Access Compliance Report

Public Rights-of-Way

(Curb Ramps)

Intersection ID: 10033074	Main Street: NORTH_COMMUNITY_HOUSE_RD	Cross Street: N/A	Location: NE
ADA ID: 614ADF018B64	Ramp Type: PerpDiag	Initial Pass/Fail: Fail	Overall Compliance: No
Severity Score: 33.75			
Codes/Mitigation Info/Possible Solution		Field Measurements/Component Compliance

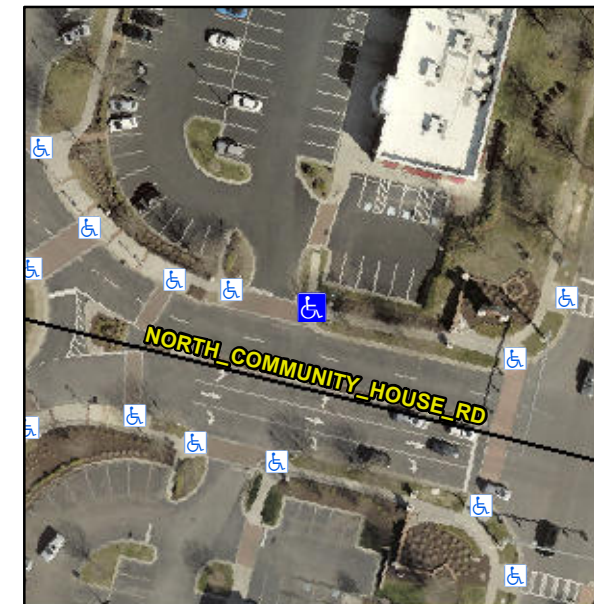
R304.5.1, R304.5.3

Compliance	Description	Data	Compliance	Description	Data
N/A	Ramp Length (in)	143.0	Yes	Ramp Slope (%)	5.2
No	Ramp Width (in)	41.0	No	Ramp XSlope (%)	7.9
N/A	Flare Type LT	N/A	N/A	Flare Type RT	N/A
N/A	Flare Slope LT (%)	N/A	N/A	Flare Slope RT (%)	N/A
N/A	Flare Traversable LT?	N/A	N/A	Flare Traversable RT?	N/A
N/A	Landing Length (in)	N/A	N/A	DWS Provided?	N/A
N/A	Landing Width (in)	N/A	N/A	DWS Contrast?	N/A
N/A	Landing Slope (%)	N/A	N/A	DWS Length (in)	N/A
N/A	Landing X Slope (%)	N/A	N/A	DWS Full Width?	N/A
N/A	Landing Curb? (Y/N)	N/A	N/A	DWS Offset (in)	N/A
N/A	Shared Landing?	N/A			
N/A	Gutter Ponding?	N/A	N/A	Gutter Slope (%)	N/A
N/A	Gutter Lip Ht (in)	N/A	N/A	Gutter X Slope (%)	N/A
N/A	Painted X Walk1?	Yes	N/A	Painted X Walk2?	No
	X Walk 1 Direction	To W		X Walk 2 Direction	To S
N/A	X Walk 1 Width (in)	120.0	N/A	X Walk 2 Width (in)	N/A
	X Walk 1 Slope (%)	2.8		X Walk 2 Slope (%)	3.8
	X Walk 1 X Slope (%)	3.6		X Walk 2 X Slope (%)	4.8

N/A	Ramp inside XWalk1?	Yes	N/A	Ramp inside XWalk2?	N/A
	Road Slope (%)	4.5	N/A	Clear Space?	N/A
	Road X Slope (%)	0.5	N/A	Clear Space to XWalk (in)	N/A
N/A	Any Obstructions?	N/A	N/A	Storm Grate/Utility Hazard?	N/A
	Obstruction Type			Storm Grate/Utility Type	
		N/A			N/A
		Yes		Surface Condition? (G/P)	Good

Remove & Replace Curb Ramp With Two New Directional Ramps or Equivalent.
